Department of Energy

RESPONSES TO THE U.S. ENVIRONMENTAL PROTECTION AGENCY AND OHIO ENVIRONMENTAL PROTECTION AGENCY COMMENTS ON THE REMEDIAL DESIGN PACKAGE FOR THE SILO 3 PROJECT

OHIO EPA COMMENTS ON
SILO 3 REMEDIAL DESIGN PACKAGE

ISOPLETHS OF RADON AND PARTICULATE CONCENTRATIONS

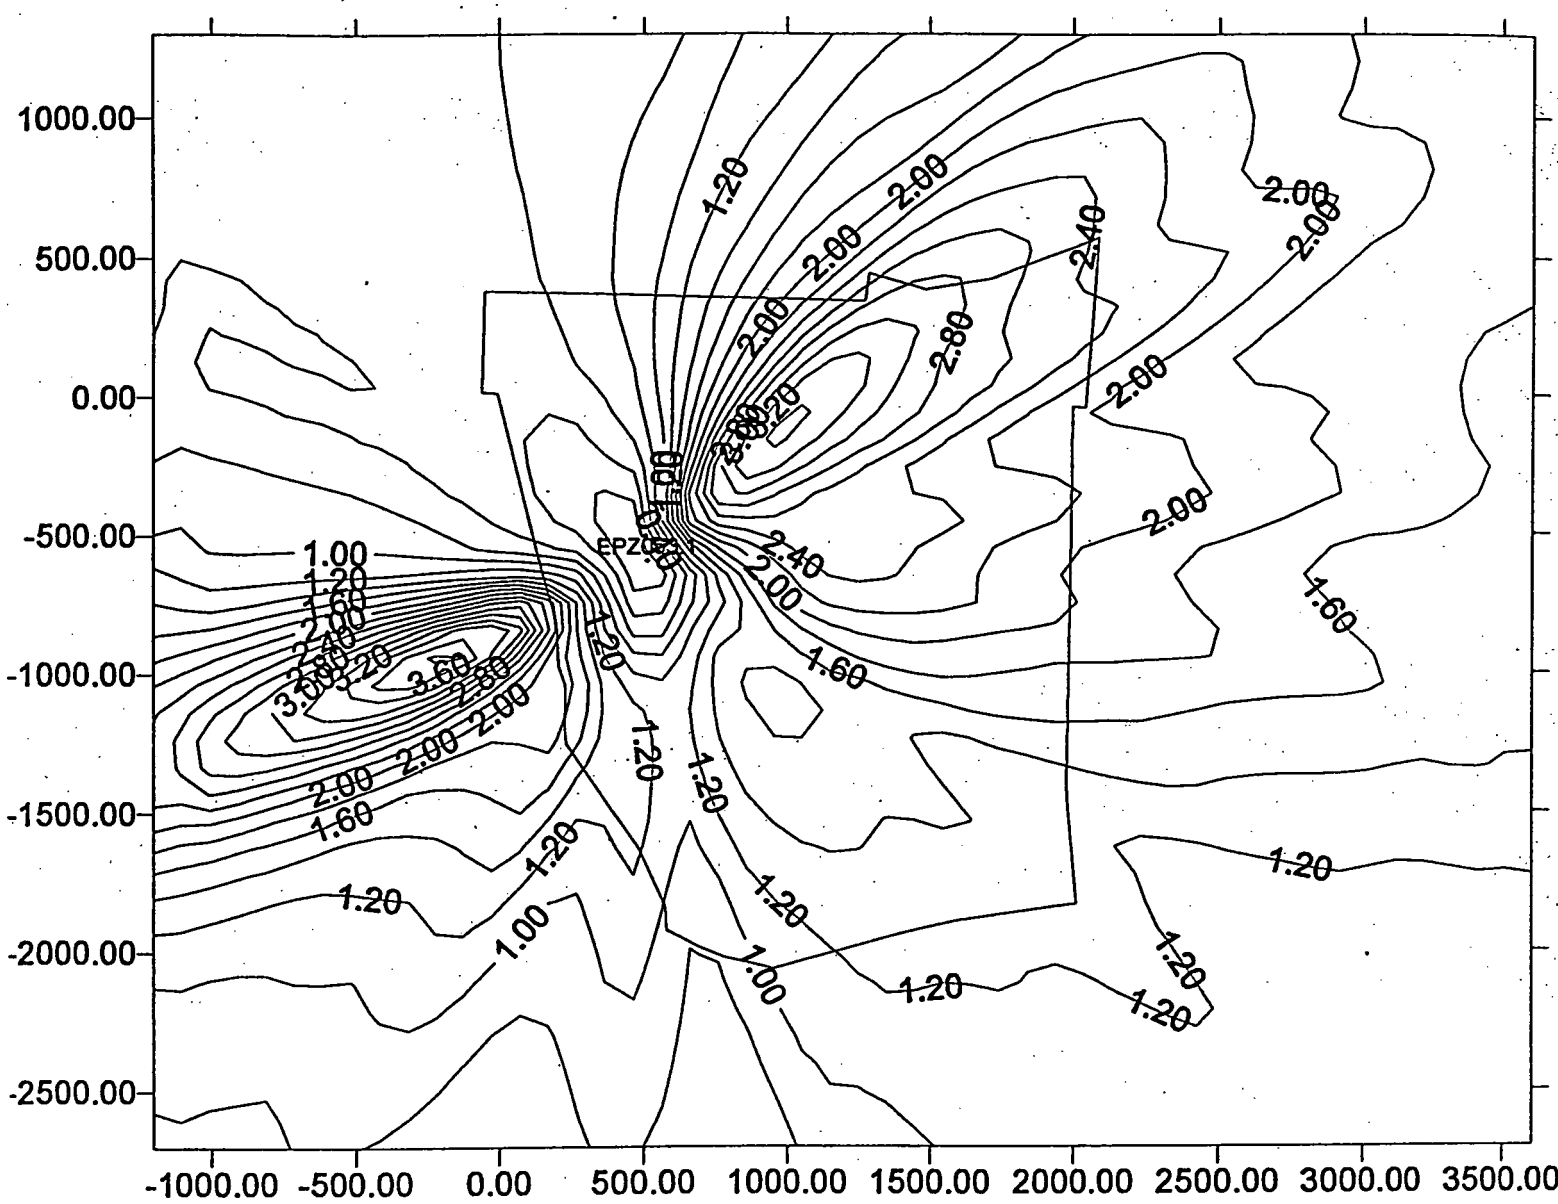
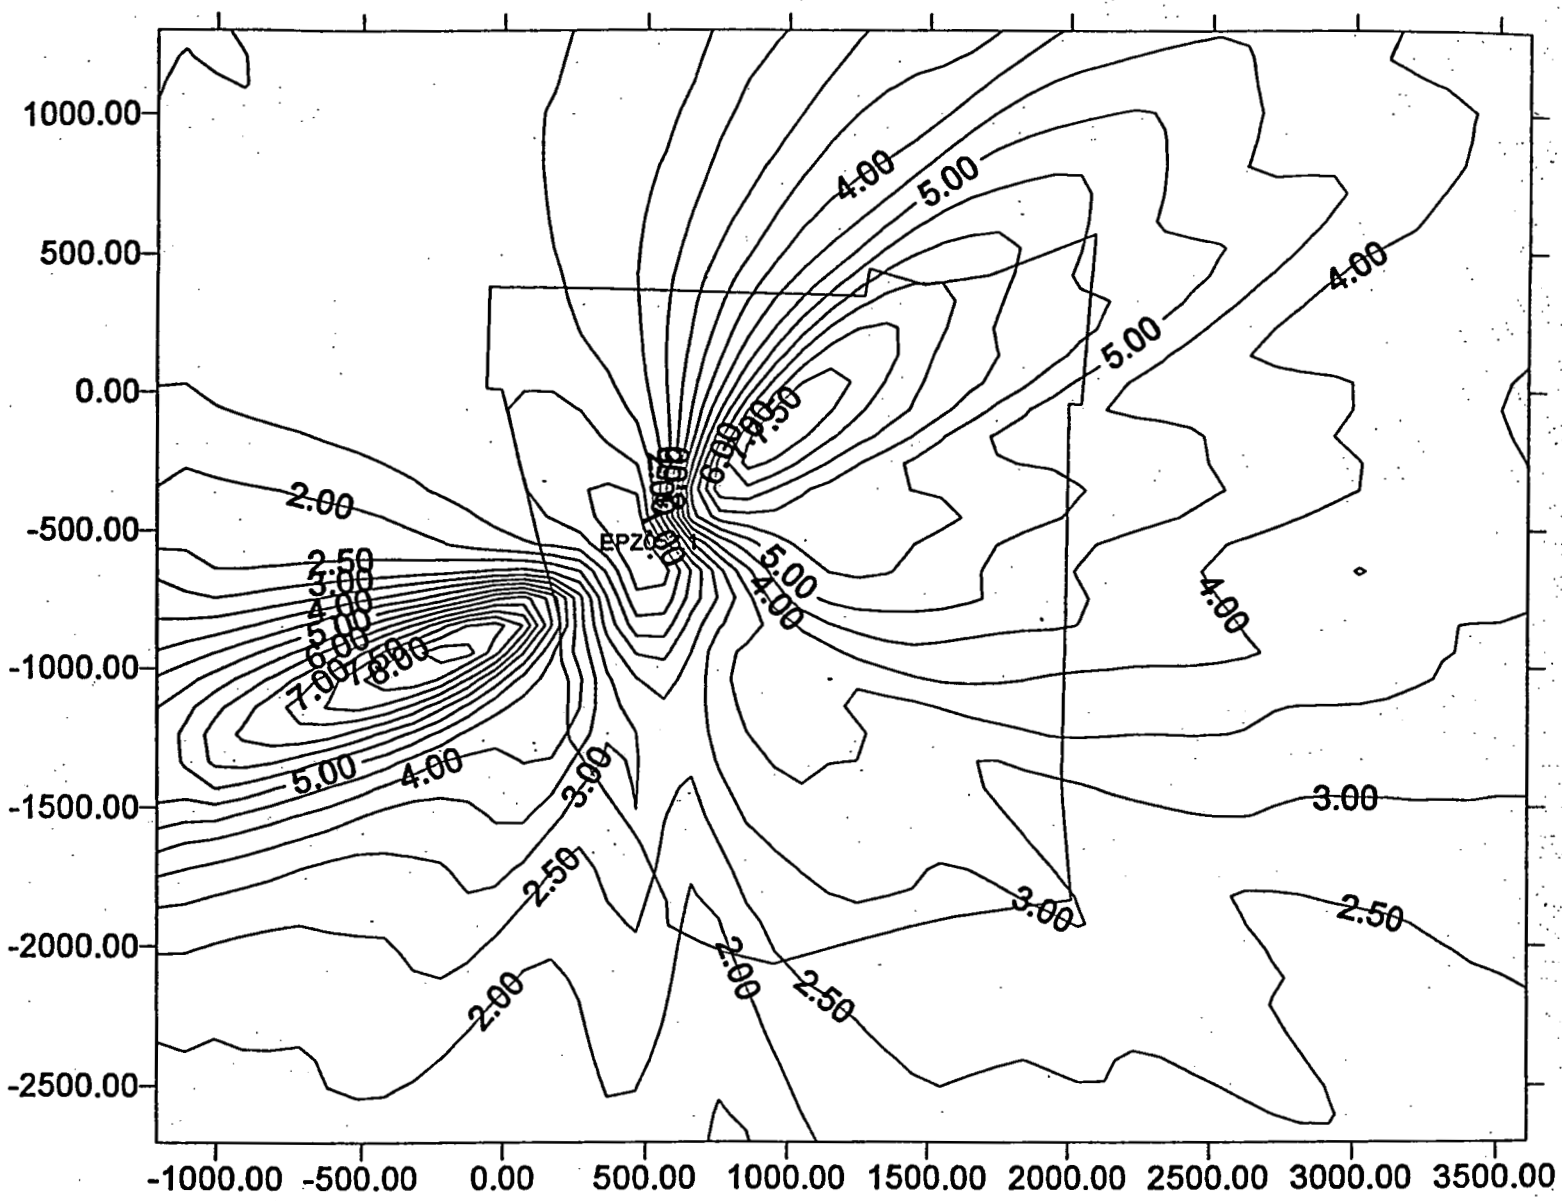
40. Commenting Organization: Ohio EPA Commentor: OFFO
Section #: 5.0 Pg #: General Comment Line #: Code: C 3198
Original Comment #:
Comment: The section also need to include isopleths of modeled air plumes for radon and particulate.

Response: Figures depicting isopleths of radon and particulate concentrations in the Silo 3 Project area are attached.

Exhibit 4.1-4: Kraft Slave Arm with 8-in. Hose and Retractable Nozzle 3198.

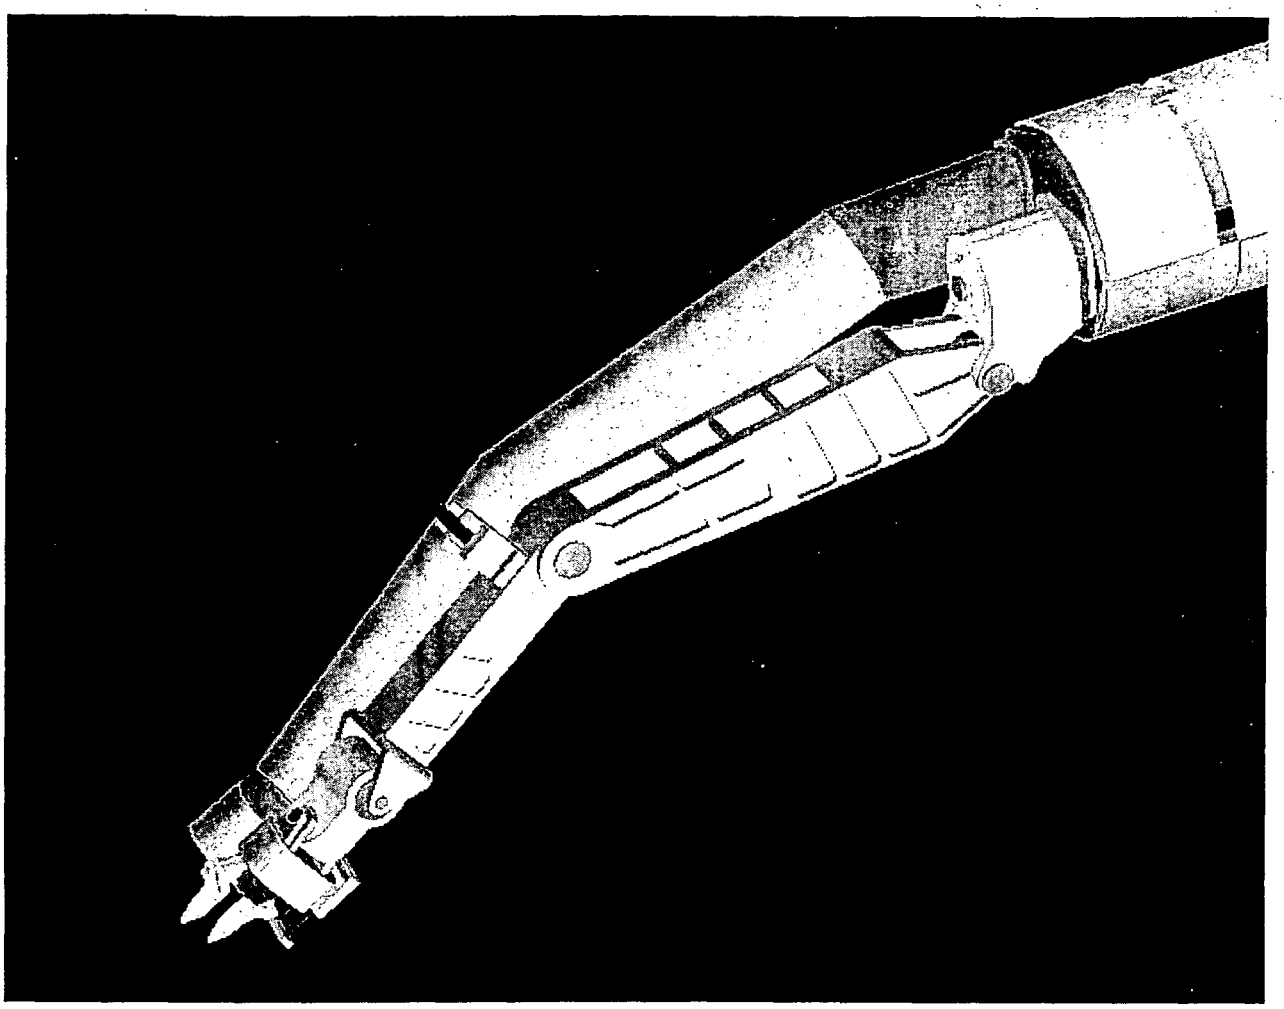
15. Commenting Organization: Ohio EPA Commentor: OFFO - 3198
Section #: 2.2 Pg #: 7 Line #: Code: E
Original Comment #:
Comment: The description for Exhibit 4.1-4 says "Kraft Save Arm...". "Save" should be "Slave".

Response: Text will be corrected as noted.
